SUBJECT: ARKANSAS NUCLEAR ONE, UNIT 2 - ISSUANCE OF AMENDMENT NO. 325  
RE: REVISE LOSS OF VOLTAGE RELAY ALLOWABLE VALUES AND  
NUMBER OF DEGRADED VOLTAGE CHANNELS (EPID L-2020-LLA-0193)

SAFETY EVALUATION BY THE OFFICE OF NUCLEAR REACTOR REGULATION

RELATED TO AMENDMENT NO. 325 TO

ARKANSAS NUCLEAR ONE, UNIT 2

**Figure 1: Licensee’s Summary of the Calibration of the LOV Relay**

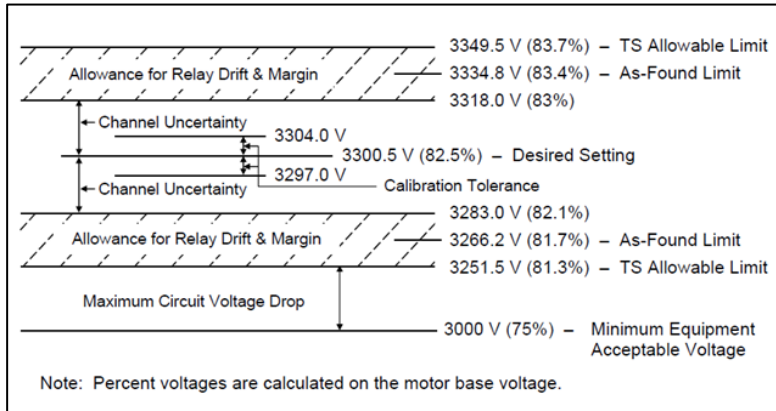
Using the licensee’s equations and information in Figure 1 above, the NRC staff summarized the following results of the licensee’s calculations in Table 1 below:

Based on the information in Table 1 and Figure 1 above, the NRC staff used the guidance in RG 1.105, Revision 3, to independently confirm whether there are adequate margins for instrument channel performance uncertainty between the AL and  $V_{DRD}$  or NTS ( $\text{Margin}_{NTS}$ ) and associated AV ( $\text{Margin}_{AV}$ ) (for Functional Unit 7.a in ANO-2 TS Table 3.3-4 of Section 3.3.2.1) to satisfy the requirements of 10 CFR 50.36(c)(1)(ii)(A). It should be noted that the NRC staff performed an evaluation of the  $\text{Margin}_{NTS}$  and  $\text{Margin}_{AV}$  of the lower level only because the

Based on the information in Table 1 and Figures 1 and 2 above, the NRC staff has determined the following with respect to the proposed AV for the LOV Relay in ANO-2 TS 3.3.2.1, specifically Functional Unit 7.a in TS Table 3.3-4:

- The NTS, inclusive of their AFTs, are less than the maximum AV and greater than the minimum AV, and therefore, would assure that the trip signals will be initiated before the NTS reached the AV values.
- The margin ratio percentage between the NTS and AV margins is greater than 83 percent and is adequate. These margins ensure that the trip setpoints have been chosen to assure that a trip or safety actuation will occur significantly before the measured process reaches the lower ALs (minimum equipment acceptable voltage). The proposed AV setting supports an automatic protective action that will correct the abnormal situation before a safety limit is exceeded.

- The proposed maximum and minimum TS AVs of the LOV relay are higher than the minimum allowable motor terminal momentary voltage of 75 percent of the motor voltage rating of 4000 V to ensure that 4160 V and 480 V motors will not stall if already running, and to maintain these variables and systems within prescribed operating ranges.

Based on the above discussion, the NRC staff finds that the proposed LOV relay settings (maximum and minimum AVs) for Functional Unit 7.a in Table 3.3-4 of TS Section 3.3.2.1 are consistent with RG 1.105, Revision 3, satisfy the requirements of 10 CFR 50.36(c)(1)(ii)(A), and continue to meet GDC 13. Therefore, the proposed AVs ( $3300.5 \pm 49$  V) are acceptable.

**Figure 2: LOV Relay AVs and NTS (or V<sub>DRD</sub>) Relationships and Margins Calculated by the NRC Staff**

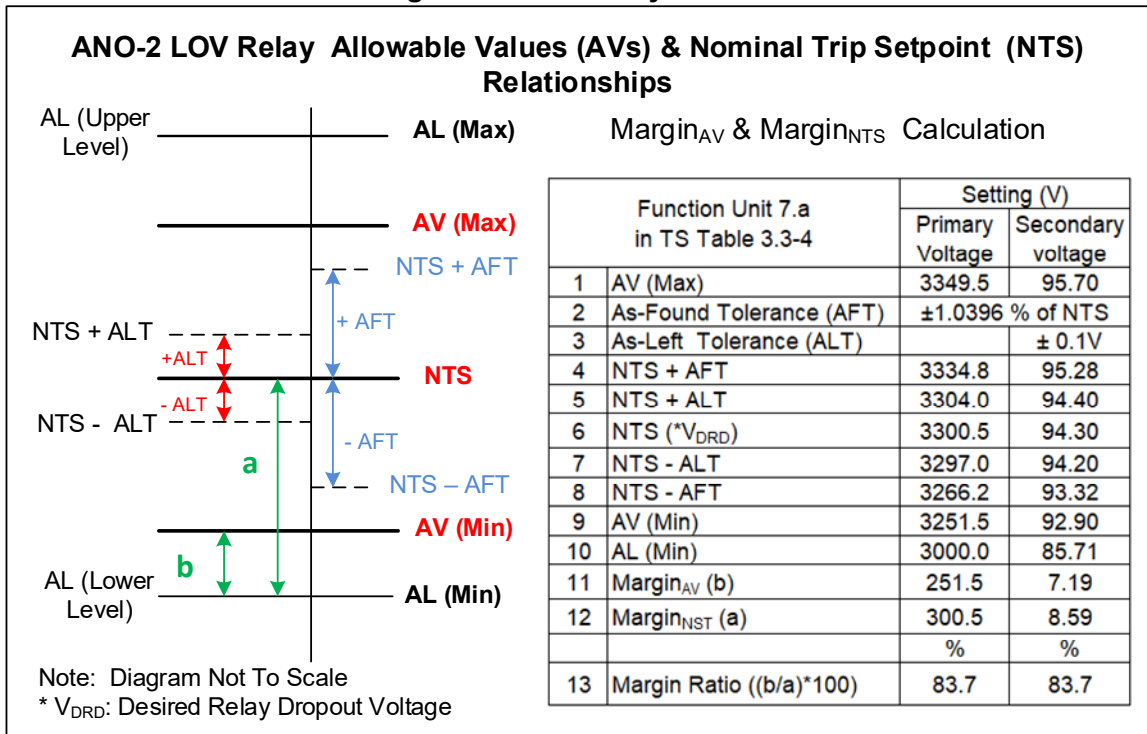
In this confirmatory evaluation, the NRC staff considered the minimum equipment acceptable voltage (3000 V) as the AL of the lower level. The NRC staff's evaluation and confirmatory results are summarized in Figure 2 below:

**Figure 3: LOV Relay Time Delay Settings Relationships and Margins Calculation by the NRC Staff**

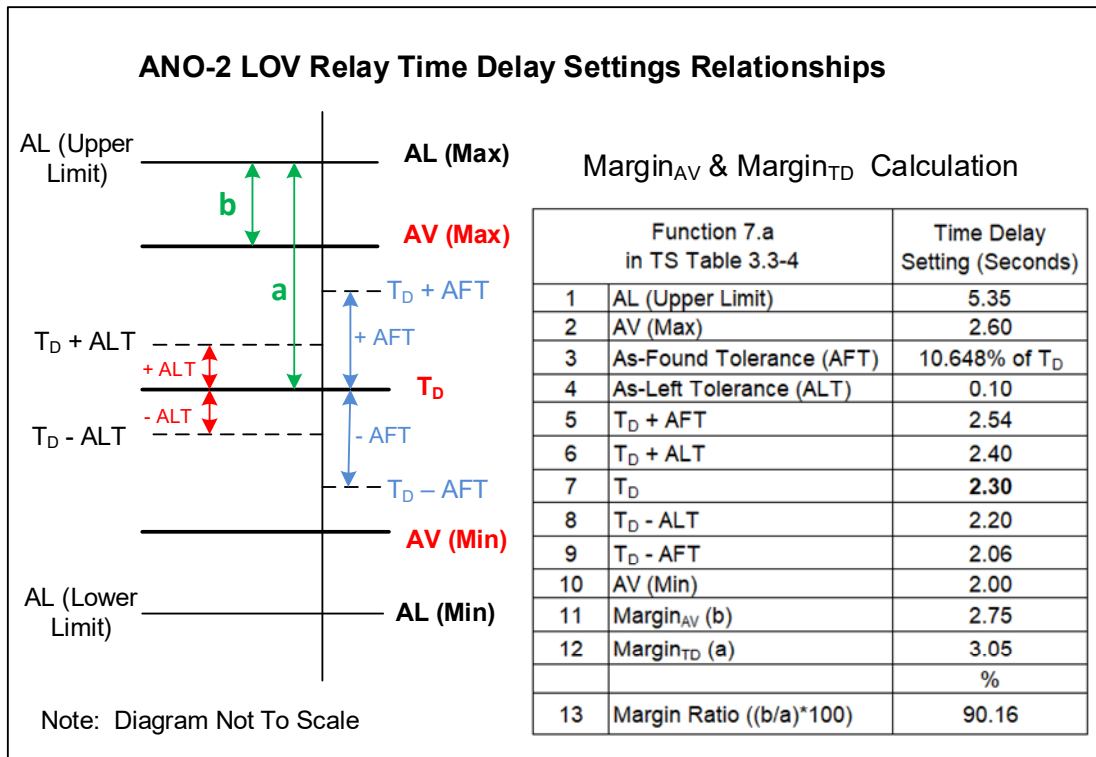
The NRC staff's evaluation is summarized in Figure 3 below.

Based on the information in Table 2 and Figure 3 above, the NRC staff has determined the following with respect to the proposed AV for the LOV relay time delay associated with Functional Unit 7.a in Table 3.3-4 of Section 3.3.3.2.1 of ANO-2 TS:

- The  $T_D$ , inclusive of the AFTs ( $\pm$  AFTs), ( $T_D + \text{AFT}$ ) is less than the maximum AV, and ( $T_D - \text{AFT}$ ) is greater than the minimum AV, and therefore, would ensure that the trip signals will be initiated before the  $T_D$  reaches the AV values.

- The margin ratio percentage between the  $T_D$  and AV margin is greater than 90 percent and is adequate. This margin ensures that the trip setpoint has been chosen to assure that a trip or safety actuation will occur significantly before the measured process reaches the Upper ALs. The proposed AV setting supports an automatic protective action that will correct the abnormal situation before a safety limit is exceeded.

- The proposed maximum/minimum TS AV is within the time delay setting range of 2 to 20 seconds of the ABB vendor manual for Type 27N undervoltage relays, Model 411T5175-HF-L, and would maintain the associated variables and systems within prescribed operating ranges.

Based on the above discussion, the NRC staff finds that the proposed AVs of the LOV time delay settings (maximum and minimum AV time delay) for SR 3.3.8.2.b (SR for the channel calibration performance) were developed consistent with the guidance in RG 1.105, satisfy the requirements of 10 CFR 50.36(c)(1)(ii)(A), and continue to meet GDC 13. Therefore, the proposed AVs for the relay time delay settings ( $\leq 2.6$  seconds and  $\geq 2.0$  seconds) are acceptable.
